PUBLIC NOTICE
LOUISIANA DEPARTMENT OF ENVIRONMENTAL QUALITY (LDEQ)
MIKEEBO INC.
TECHNICALLY COMPLETE SOLID WASTE MAJOR MODIFICATION

RE: Notice of Technical Completeness
Mikeebo, Inc.
Major Modification – Geotechnical Investigation
AI #117009 / D-017-12376 / P-0381/PER20070001
Caddo Parish

**NOTICE OF DEFICIENCIES
RESPONSE**

RE: Landfill Cell Expansion
Major Modification NOD #1
Mikeebo, Inc.
Type III Construction/Demolition Debris and Woodwaste Landfill
D-017-12376/AI #117009/PER20030001/P-0381
Caddo Parish

Figure 7
Soil Boring and Test Pit Locations
Mikeebo, Inc. - Shreveport, LA

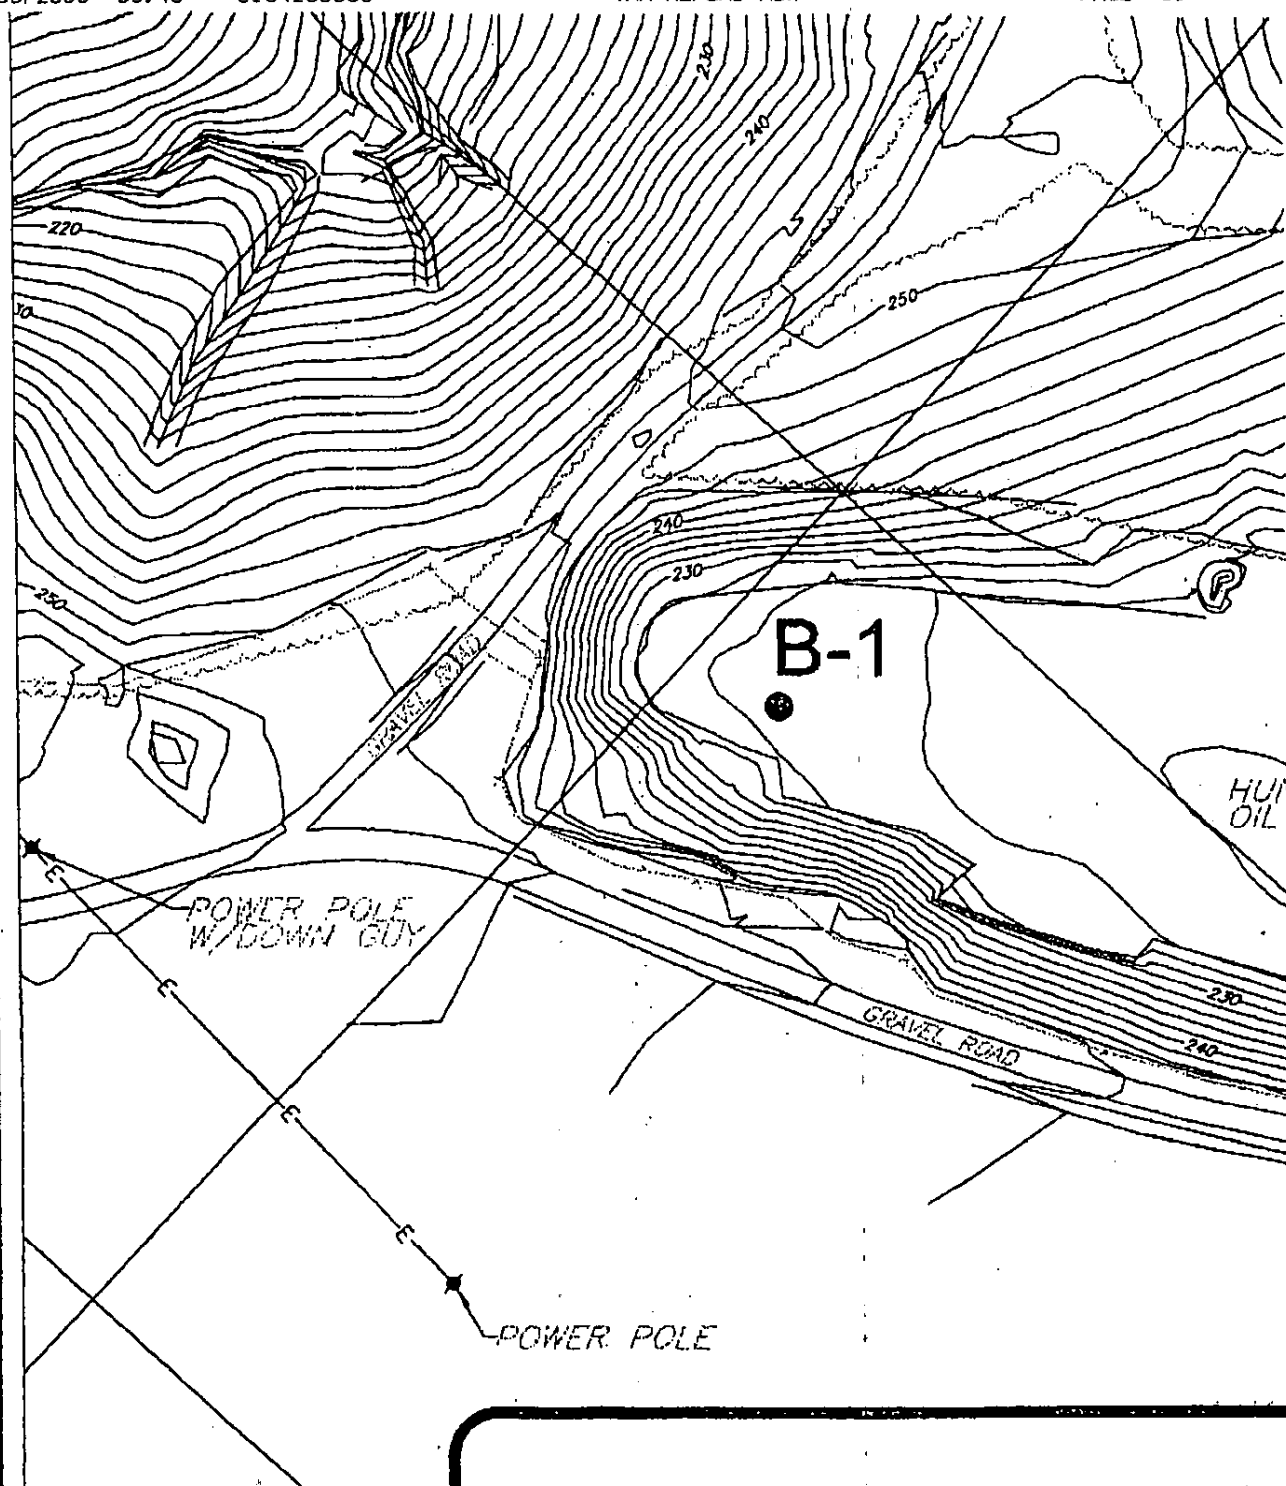
§522.A.2 and 3 (con't) Please provide the boring logs (soil descriptions) for the earlier borings (test pits) B-1, B-2 and B-3 conducted in 2003.

Site soils consist of clay, sandy clay, clayey silt, and clayey sand. Three test pits were excavated to a depth of five feet. Adjacent to the test pits, three soil borings were conducted to a depth of five feet below ground surface within the existing borrow pit as depicted in the figure at the end of Attachment C.

FIGURE C-7

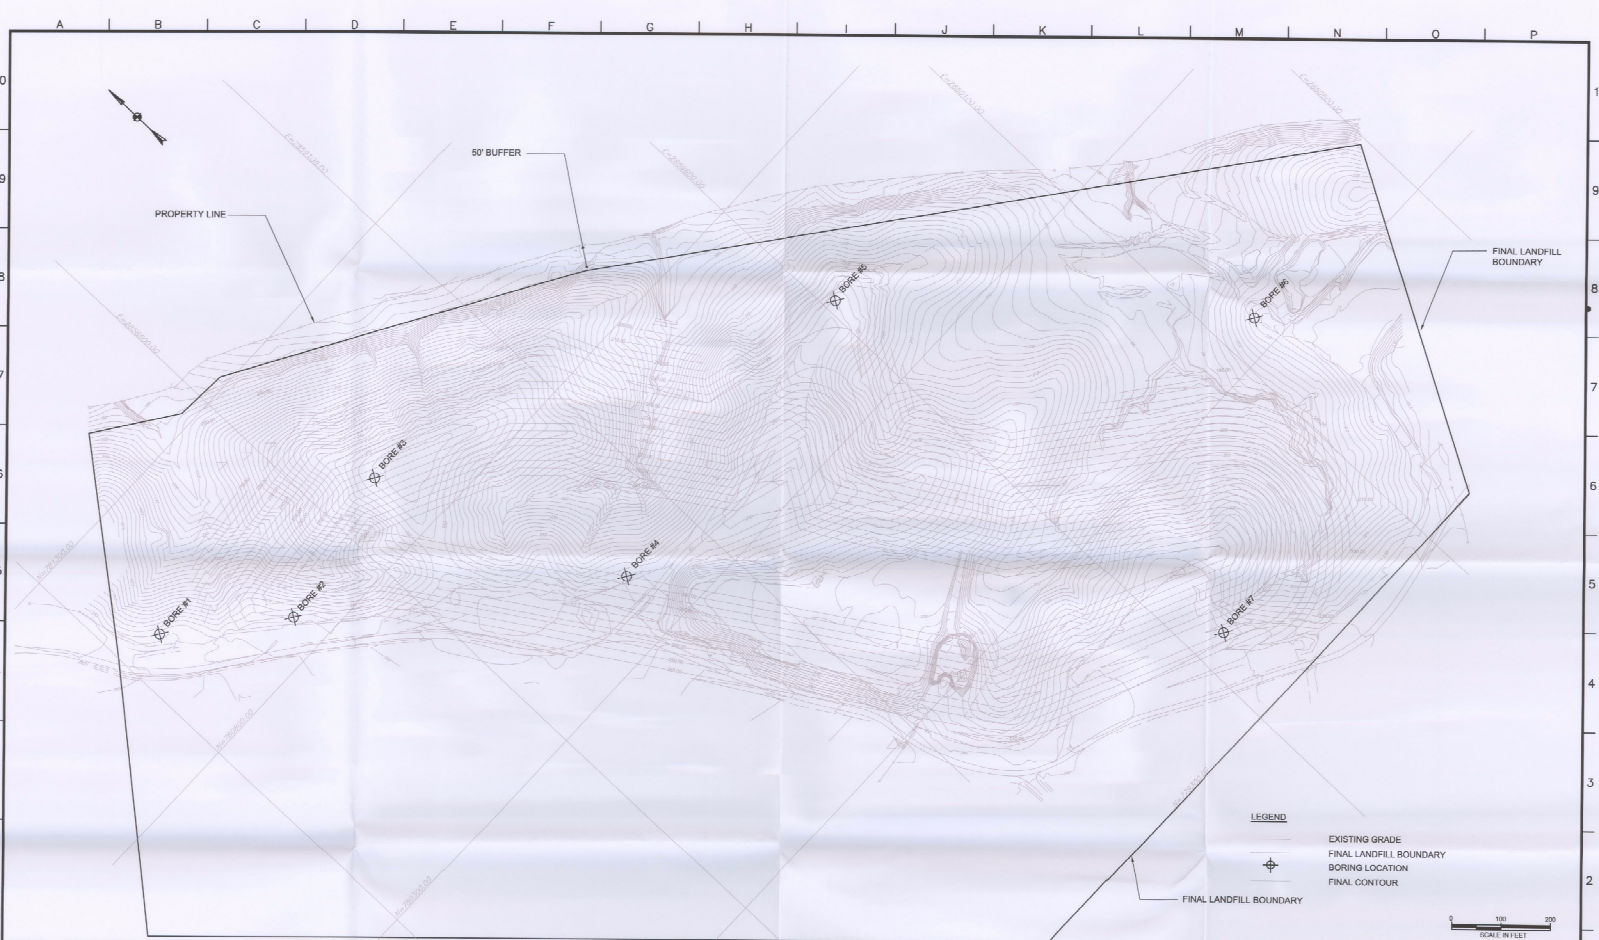
The boring requirement information of 803.A.1.d and 3 (maps) shall be submitted. The existing topographic contours provided in Figure C-7 of the application are not legible.

A revised, enlarged, and more legible edition of Figure C-7 is provided as Attachment D.
